Amendments to the Drawing

Remarks

U.S. Application No.: 10/613,017

Docket No.: D-1485

**Fig. 33(d)
Prior Art**

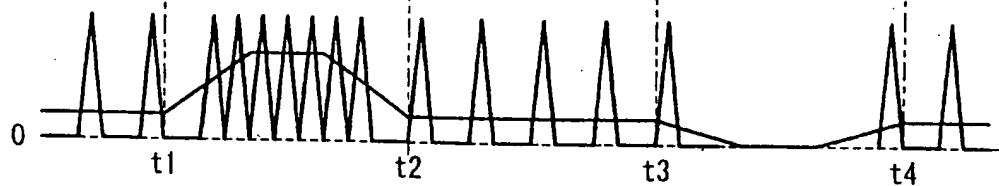
In Figs. 33(a) to 33(d), one of the drawings originally shown was not labeled, and the locations of Figs. 33(b) to 33(d) were incorrect. Therefore, the locations of Figs. 33(b) to 33(d) have been corrected, and label of Fig. 33(e) has been added.

In regard to Figs. 33(a) to 33(d), although five drawings are shown in one sheet, labels of Figs. 33(a) to 33(d) were indicated. Figs. 33(a) to 33(e) should be labeled.

The marked up drawings (Fig. 6 and Figs. 33(b) to 33(d)) and replacement sheets thereof are attached herewith.

In accordance with 37 CFR § 1.121, replacement drawing sheets for Figs. 6 and 33(a)-33(e) are attached hereto.
